RE: Revised Preliminary Subdivision Application Durant Homestead, Residential Subdivision.

Email Comments from Jonathan Earle, PE, dated September 6, 2018:

Memo Comments from Amanda Lessard, Planner dated September 4, 2018:

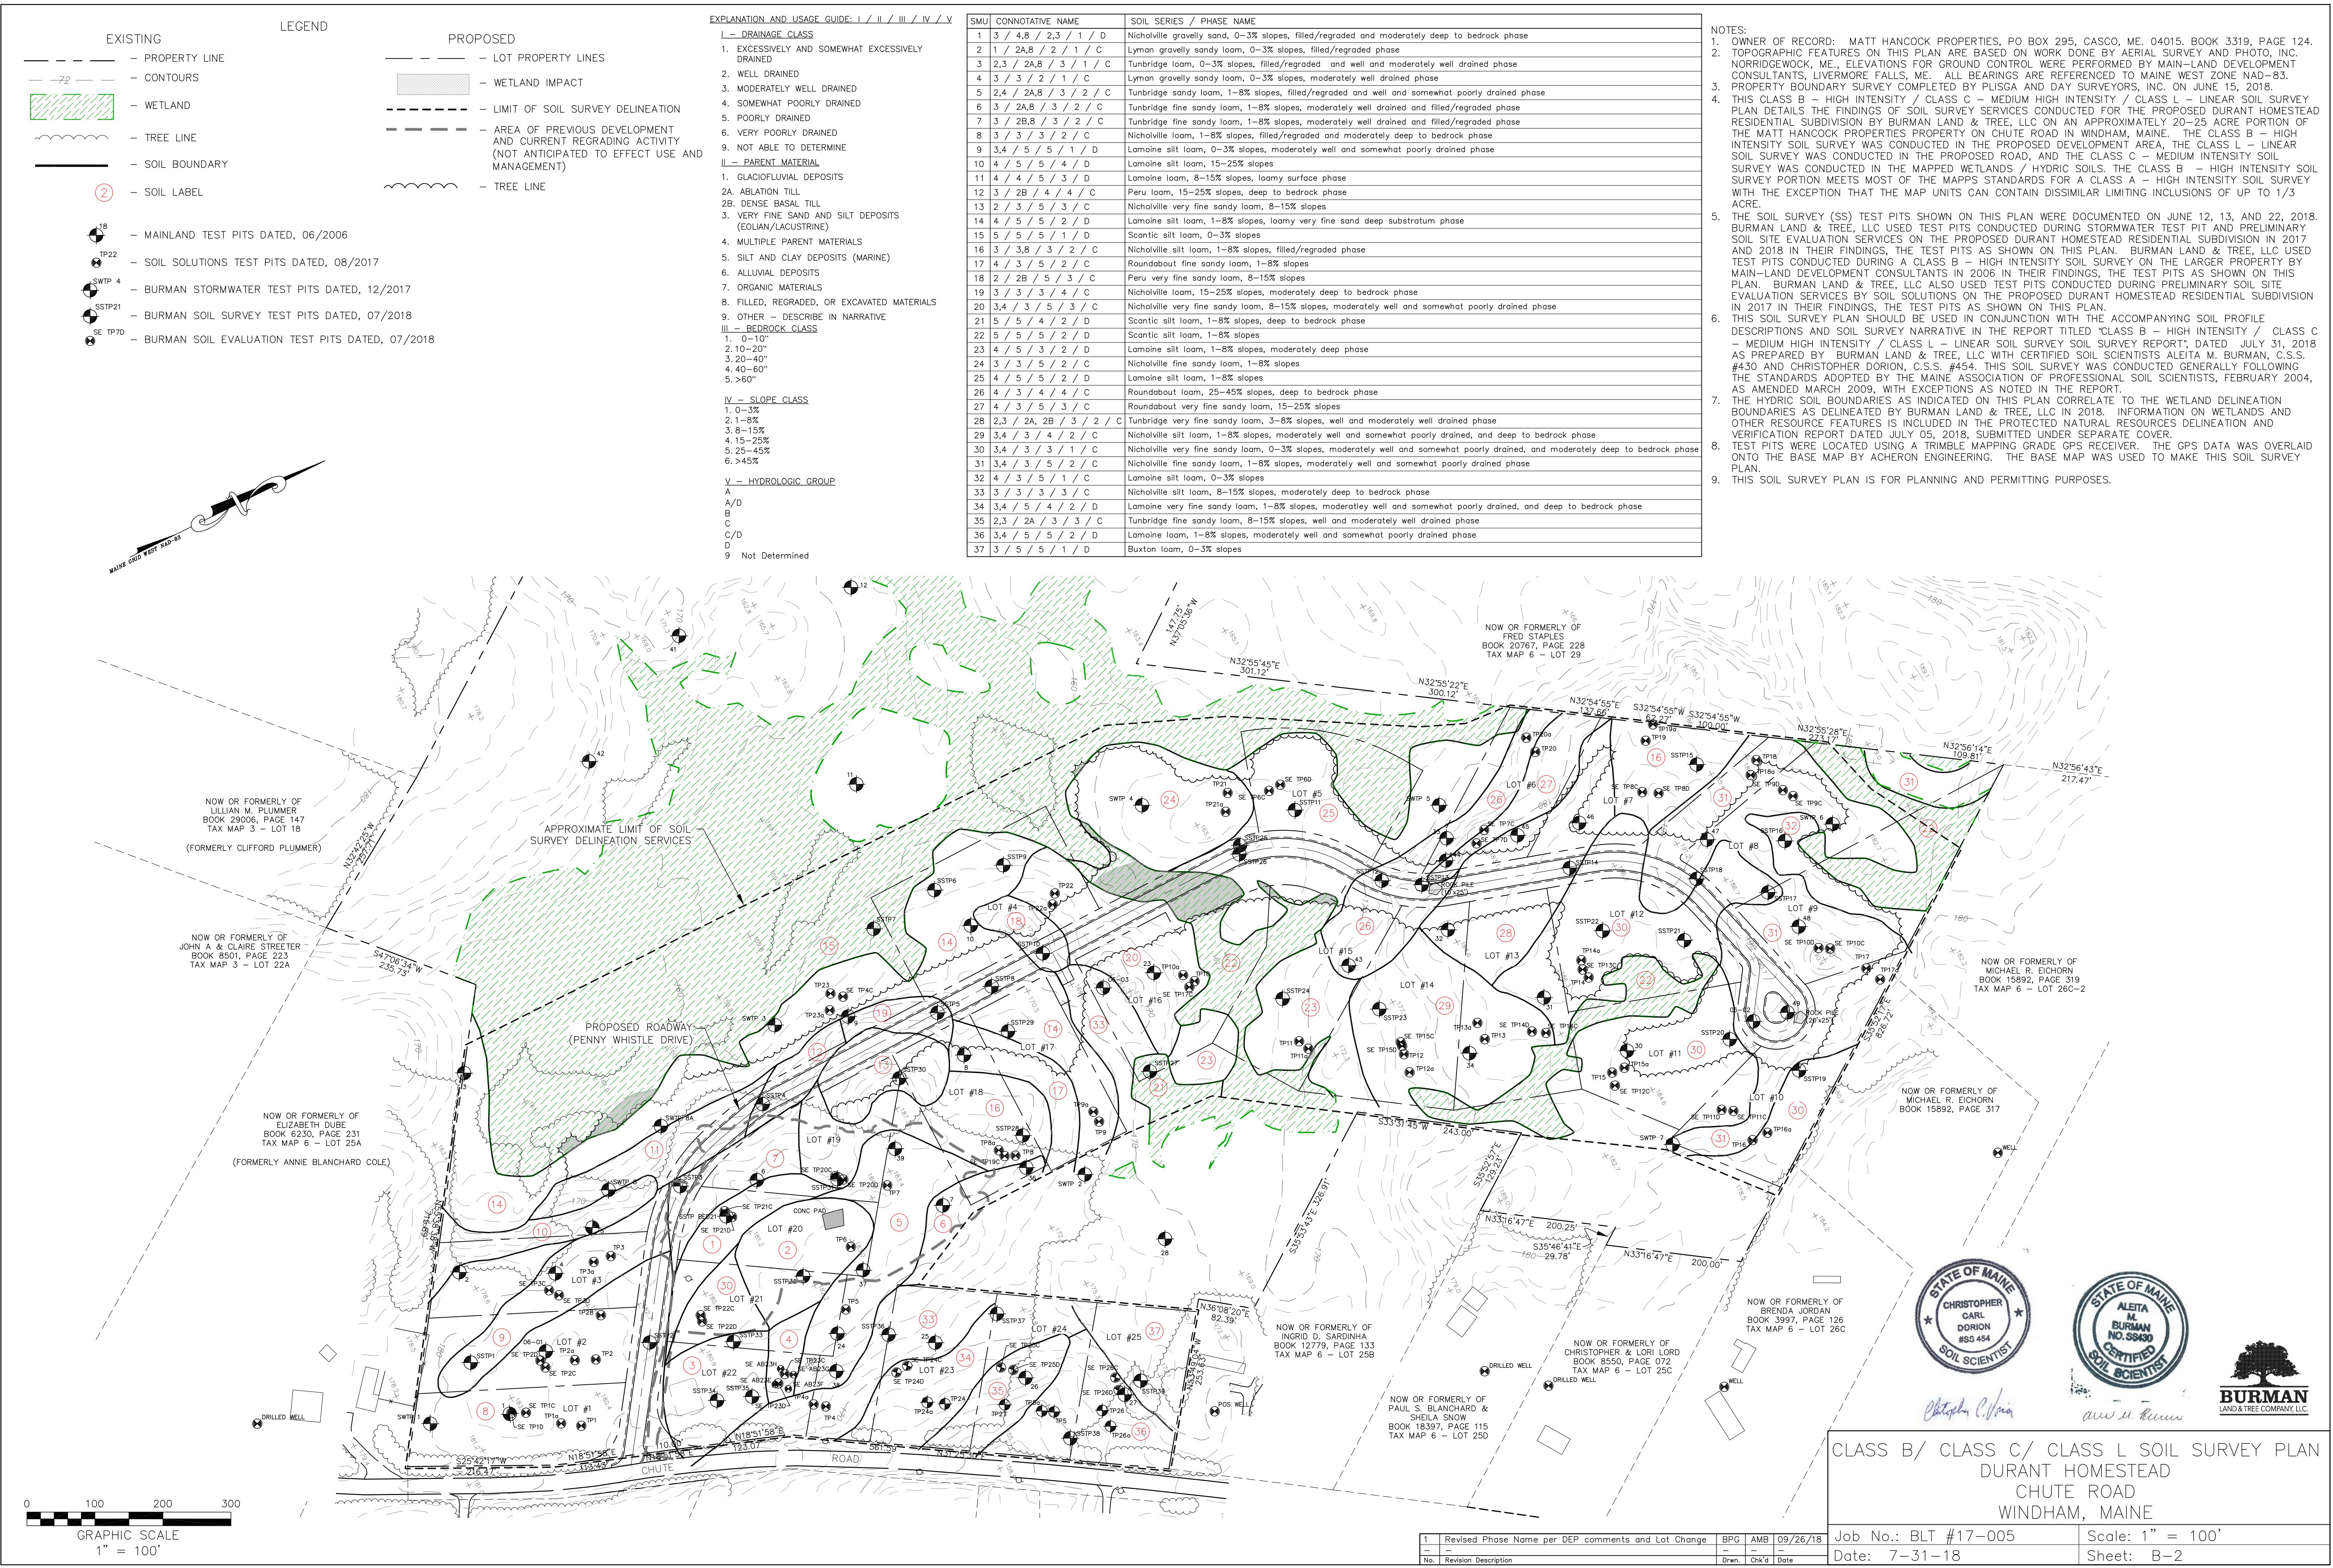
10. *Adequate separation distance should be provided between the proposed disposal field and well on lot 3 on plan sheet B-2 of the soil/site evaluation report, dated 7-13-18. The distance shown on the plan appears to be less than 100 feet as measured by scale rule, which does not comply with Table 7B of the Subsurface Wastewater Disposal Rules.*

The attached plan sheet C-2 and the Preliminary Subdivision Plan have been revised to include the following requirement: "Lot 3: LPI approval required for a reduction in the setback between the leachfield and the drilled well, to include greater depth of well casing or liner seal below ground level, as per Table 7A in Section 7 of the Subsurface Wastewater Disposal Rules (as amended August 03, 2015)."
